Exhibit 2

Reasons why the determinations outlined in Exhibit 1 should be reversed.

The Mui Ho Fine Arts Library in Rand Hall at Cornell University is in violation of the following provisions of the 2015 New York State Building Code:

Figure 1. (a) View, from left to right, of interconnected Sibley, Milstein, and Rand Hall; and (b) second-floor plan showing net second-floor areas of Milstein, E. Sibley, and Rand Halls.

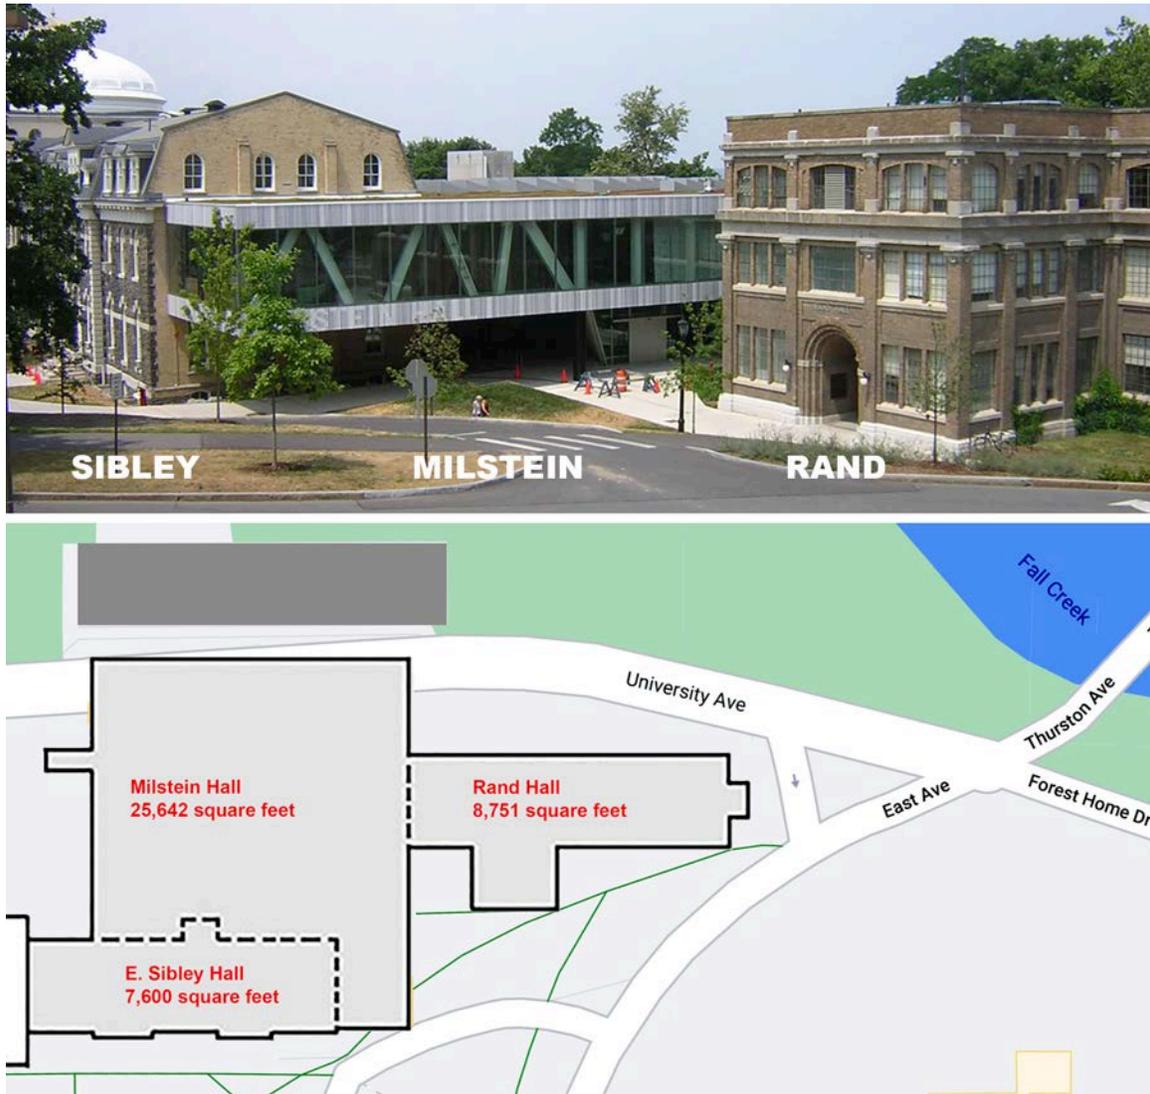
Before being connected to Milstein Hall in 2011, Rand Hall was a 3-story Type IIB non-fireproofed steel frame building and E. Sibley Hall was a 3-story Type VB building (with non-fireproofed wood exterior bearing walls at the third floor). Since the two buildings were connected to 2-story Milstein Hall without fire walls (Figure 1), Rand-Milstein-Sibley Hall became a *single building* with Type VB construction.

Explanation: Without recourse to superseded variances, no longer applicable because the current building design is substantially different from prior designs for which variances were granted, Rand-Milstein-Sibley Hall is a single building with Type VB construction and an actual second-floor area of 41,993 square feet. Assuming a frontage factor of 0.57 (per Section 506.3), the allowable single-floor area for a sprinklered Type VB building governed by Occupancy Group A-3 is $18,000 + 0.57(6,000) = 21,420$ square feet, per Table 506.2 (Figure 11). Therefore, the allowable area is exceeded and the proposal is noncompliant. Even if wood-framed Sibley Hall is entirely eliminated from consideration, the remaining hypothetical Milstein-Rand combined building still has an actual second-floor area of $25,642 + 8,751 = 34,393$ square feet. Assuming the same frontage factor, and even “upgrading” the construction type to IIB (non-fireproofed steel frame), the allowable per-floor area of $28,500 + 0.57(9,500) = 33,915$ square feet is still exceeded by the actual area and so even this hypothetical combined building with reduced size and increased fire resistance remains noncompliant. Only by building a fire wall between Rand and Milstein

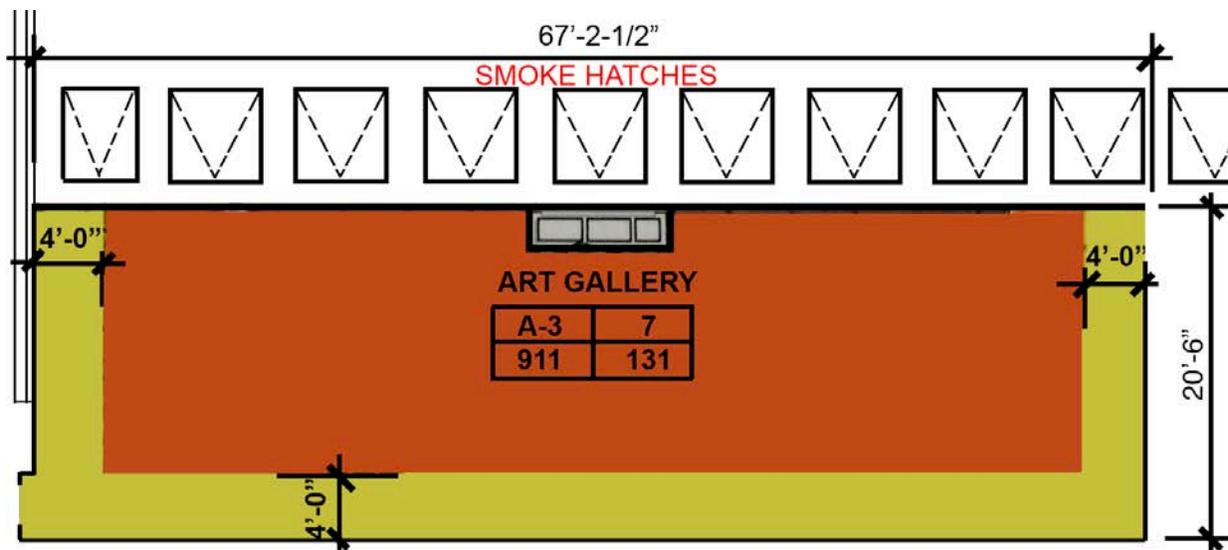
Explanation: The stated occupancy for the roof-top art gallery of 131 is found by using an incorrect gallery area of 911 square feet and an incorrect occupant load factor of 7 square feet per occupant (Figure 2). The *actual occupancy is 263*, based on an actual area of $67'-2-1/2" \times 20'-6"$ = 1,315 net square feet and an occupant load factor of 5. In this calculation, I have computed the gallery area by first subtracting 6 inches from the circulation zone edges and then subtracting 20 square feet for a utility enclosure on the north side of the gallery. This actual area includes the hypothetical egress pathways at the perimeter of the gallery space that are colored yellow on the architect's plans, sheet LSP-103 (Exhibit 4), apparently, and deceptively, to imply that they might represent something literally separated from the orange-colored main gallery space (Figure 2). In fact, the entire *actual* gallery area—i.e., both the orange and yellow zones drawn by the architects—must be accounted for when computing the occupancy of the space.

The architects inappropriately *subtracted* this yellow colored circulation pathway area from the actual gallery area and used the incorrect load factor of 7 to compute the fictitious values shown on sheet LSP-103, and reproduced in Figure 2, i.e., 911 square feet for the art gallery area and $911/7 = 131$ occupants. The architects, in their "Proposed Toilet facilities Calculations" shown on LSP-100 (Exhibit 4), use an even lower number: 93 occupants.

Note that the correct occupant load factor of 5 is for "standing space" (corresponding to the actual use of the space, and consistent with the occupant load factor used, for example, in the nearby Milstein Hall art gallery) whereas the occupant load factor of 7 is for "chairs only—not fixed" a factor which does not represent the actual use of the roof-top space (see Table 1004.1.2 reproduced in Figure 3).

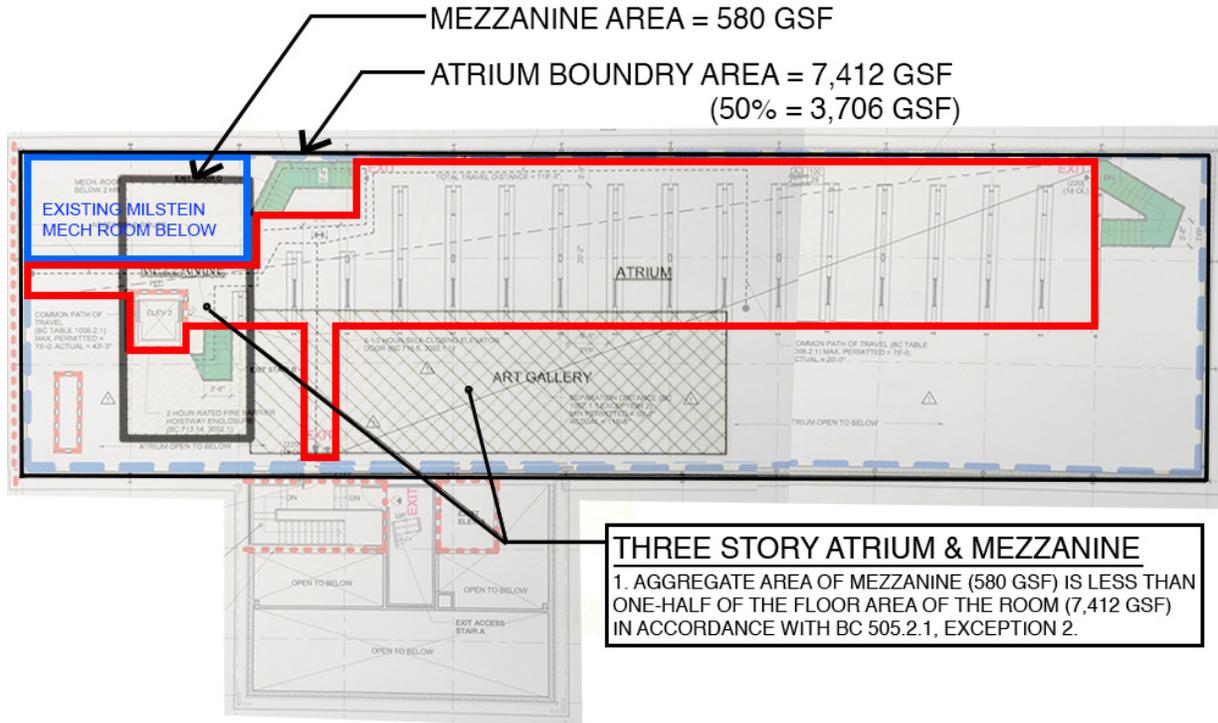
With an actual occupancy of 263 on the roof and 36 occupants on the fourth floor for a *total occupant load of 299*, the required number of plumbing fixtures, per Table 2902.1 of the New York State Building Code, is 2 WCs and 1 lav (male) and 3 WCs and 1 lav (female). The actual number of WCs provided (1 for males, 2 for females, as shown in LSP-100 reproduced in Exhibit 4) is therefore inadequate. Specifically, Note “a” for Table 2902.1 states that “fixtures shown are based on one fixture being the minimum required for the number of persons indicated or any fraction of the number of persons indicated. The number of occupants shall be determined by this code.” Section 2909.2.2 (Fixture calculations) states that “to determine the occupant load of each sex, the total occupant load shall be divided in half. ... Fractional numbers resulting from applying the fixture ratios of Table 2902.1 shall be rounded up to the next whole number.” With an actual occupant load of 299, the number of male or female occupants is 150. From Table 2902.1, the required number of male WCs (with up to 67% allowed to be replaced with urinals per Section 419.2 of the Plumbing Code) is 150/125 which rounds up to 2; and the required number of female WCs is 150/65 which rounds up to 3.

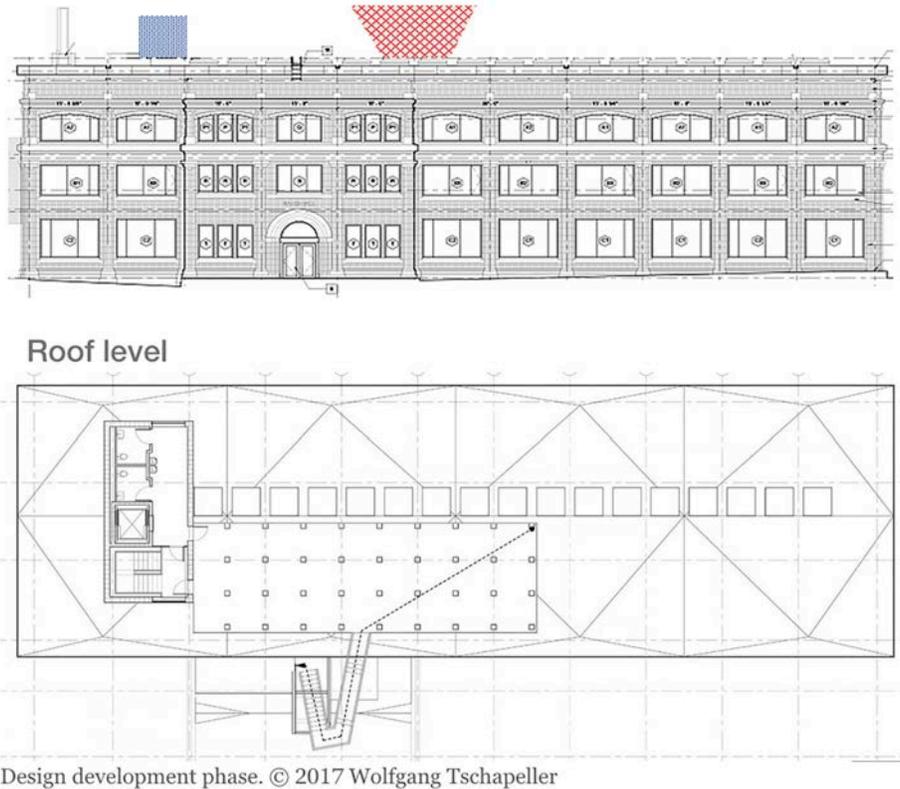
Explanation: The enclosed area on the roof, open to the atrium, is improperly classified as a mezzanine within the fourth story. Instead, it should be classified as a fifth story adjacent to an atrium. Because these roof-top spaces are adjacent to a vertical opening, their status is governed, in part, by Section 712 (Vertical Openings), which lists 16 options for compliance. Of these 16 options, only three are potentially relevant: 712.1.7 (Atriums), 712.1.11 (Mezzanine), and 712.1.12 (Exit access stairways and ramps). Section 712.1.12, as explained in the discussion of Violation #1, does not apply: James Harding of the New York State Division of Building Standards and Codes writes: “The requirements for exiting from all areas of a building are provided in chapter 10. Any portion of a building that serves as part of the required means of egress system must comply with all applicable provisions of chapter 10. Referring to Section 1006 for exit access, travel through more than one story of the building is prohibited.” Of the two remaining options, only Section 712.1.7, describing an atrium complying with Section 404, is applicable to the roof-top spaces. In other words, the roof-top spaces containing bathrooms, elevator, and corridor must be classified as a fifth story adjacent to an atrium.

The enclosed area on the roof cannot be classified as a mezzanine. To be a mezzanine, it would have to be “an intermediate level or levels *between the floor and ceiling* of any story,” as the definition in Chapter 2 of the code requires it to be. Instead, it is *on top of* the ceiling of the fourth floor. The explanation of the architects, forwarded to me in an email from the college’s Director of Facilities, Frank Parish, dated Jan. 25, 2019, states: “The enclosed area at the roof level is a mezzanine to the fourth floor. The fourth floor is open to and part of the atrium.” The architects write in their “Mezzanine diagram” on LSP-103 (Exhibit 4, reproduced below as Figure 4) that the “aggregate area of the mezzanine (580 GSF) is less than one-half the floor area of the room (7,412 GSF) in accordance with BC 505.2.1, exception 2.” This room of 7,412 GSF that is shown on the architect’s diagram is labeled as the “atrium” rather than as the fourth story, although the boundary shown for the 7,412 GSF corresponds

neither to the fourth story nor the atrium. This statement reveals two principal errors. First, a mezzanine *cannot be in an atrium*, since a mezzanine is “an intermediate level or levels *between the floor and ceiling of any story*,” and an atrium is not a “story”; rather, an atrium is an “*opening connecting two or more stories*.” Second, the roof-top enclosed spaces cannot be a mezzanine within a fourth-story room or space since there are no double-height fourth-story spaces in which a mezzanine could be placed.

By incorrectly defining the mezzanine as being within the atrium, the architects have unwittingly confirmed that it is the *atrium*, and not some fictitious mezzanine, that actually extends above the fourth-floor level in order to provide access to a roof-top story containing toilet rooms and an elevator, both of which have been made necessary by the addition of a roof-top art gallery with 263 occupants.

Figure 7. Schematic section through atrium showing how the smoke layer would migrate to the highest point of the atrium, directly in the path of egress from the roof-top art gallery through Exit Stair "B"

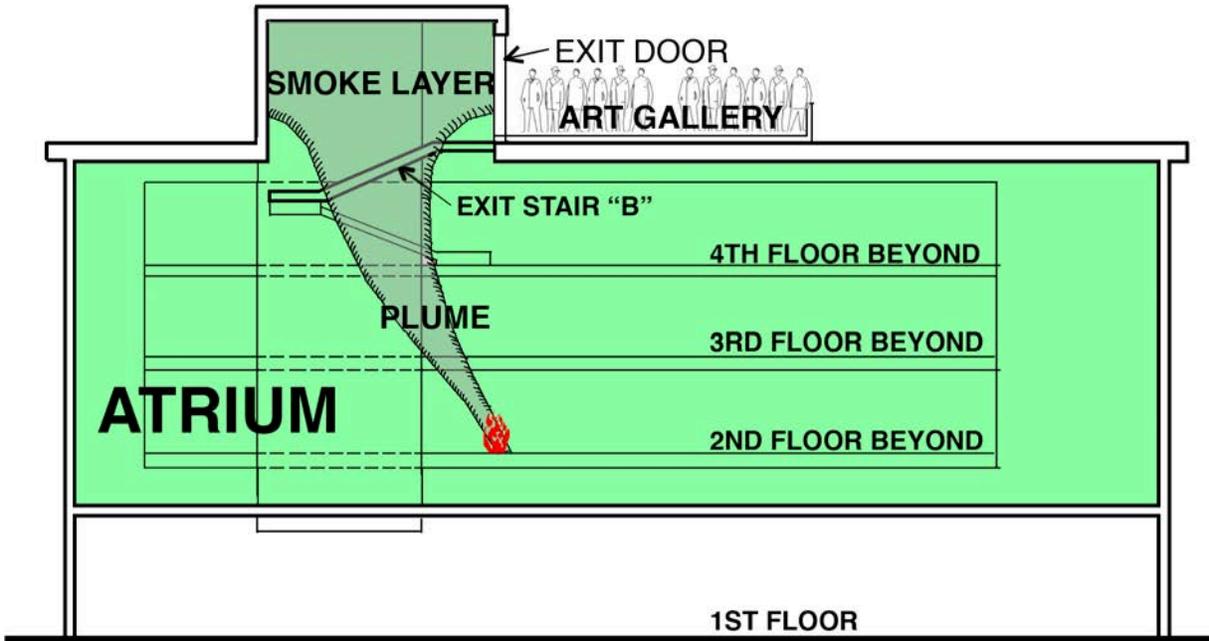
In addition to providing a 1-hour horizontal assembly between the atrium and the roof gallery, the part of the atrium that extends into the fifth story (see Figure 7 below) must also be separated from the adjacent outdoor roof gallery by a 1-hour fire barrier.

occupants. Second, since the atrium extends into the fifth floor (Figure 7), it will act as a primary smoke exhaust vent when the exit door from the roof-top art gallery is opened, even though this door is not labeled, or intended, as an exhaust vent. This smoke control system is entirely passive, with no mechanical exhaust; as a result, art gallery occupants attempting to exit through Exit Stair B will likely encounter toxic smoke emerging from the exit door, which is at the highest point in the atrium and therefore the most likely location for the hot smoke layer to migrate.

As described above, it is also uncertain, *since it wasn't part of the smoke control model*, what the time for evacuation from the roof gallery would be, and how that evacuation would take place with Exit Stair B potentially acting as a smoke exhaust vent at the highest point in the atrium. This is the stair that occupants would be most likely to use, since it is adjacent to the elevator which is the primary mode of entry *into* the roof-top gallery. In any case, it would certainly take far longer for all 263 occupants to egress from the roof-top art gallery than the 250 seconds that defines the "the tenability limit for the [fourth] floor" through which the roof gallery occupants must travel. Exit Stair B is not only unenclosed from the roof down to the second floor, but is also discontinuous, forcing those evacuating from the roof-top gallery using Exit Stair B to travel horizontally *through* the fourth floor—by now with the smoke layer making passage on this level untenable—before somehow continuing down Exit Stair B or D (both unenclosed) or across the fourth-floor bridge through the atrium space to enclosed Exit Stair A.

Figure 8. Schematic section through atrium illustrating scenario with fire location at north side of building that was not modeled in the smoke control report prepared for Cornell by GHD

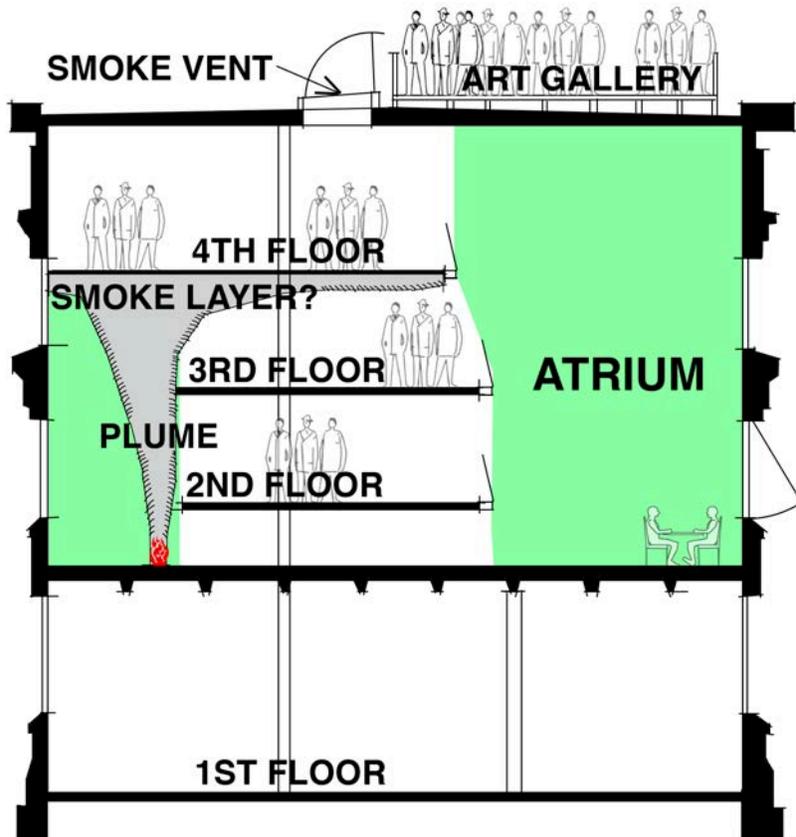
Explanation: Section 909.1 requires that the atrium smoke control system “provide a tenable environment for the evacuation or relocation of occupants.” The Atrium Smoke Control Report (Exhibit 5) prepared by GHD, Inc., dated August 7, 2017, and submitted to the City of Ithaca Building Division, *was not updated* to include the building’s occupied roof gallery with 263 occupants who, in the event of a fire, would need to egress directly through the smoke-filled upper levels of the building. This alone is sufficient cause to overturn the determinations made by the City of Ithaca and the DBSC Oversight Unit. Occupants exiting from the roof gallery during a fire event would primarily use Stair B, which is not only unenclosed as it enters the atrium below, but is interrupted by a long horizontal passage on the fourth story—also completely unenclosed—that leads to the continuation of unenclosed Stair B at the opposite end of the building, thereby exposing hundreds of occupants to the smoke that would tend to migrate precisely to this upper-level area. The Atrium Smoke Control Report draws a troubling conclusion about egress from the low-occupancy fourth story: “Fire location 1 represents the worst-case scenario in regards to smoke accumulation ... [T]he smoke layer forms enough to begin descending at approximately 240 seconds. Once the smoke layer develops it descends at an average rate of 0.06 meters per second. At approximately 250 seconds it can be observed that the *tenability limit for the top floor has been reached thus meaning that evacuation from the top floor must be accomplished before 250 seconds*. By comparing the egress times to the smoke layer descent, it can be determined that complete egress can be accomplished prior to the space becoming untenable to occupants.” [Exhibit 5] In other words, the entire viability of the smoke control system is based on the assumption that only 36 occupants are at or above the fourth floor and that these 36 occupants can exit the fourth floor within 250 seconds. However, the Atrium Smoke Control report does not consider the addition of 263 occupants exiting from the roof gallery who also must travel through this fourth floor space in order to reach the continuation of Stair B at the opposite side of the building. These occupants would certainly need substantially more time than the 250 seconds provided by this smoke control system.

The smoke exhaust system not only does *not* “provide a tenable environment” for emergency egress, but actually places occupants attempting to egress from the roof-top gallery directly in the path of toxic smoke and other exhaust products. This happens in two additional ways. First, many of the roof-top atrium smoke hatches are immediately adjacent to the occupied roof-top art gallery (see Figure 2 and Figure 8), so that smoke being exhausted through these hatches could blow directly onto roof-top
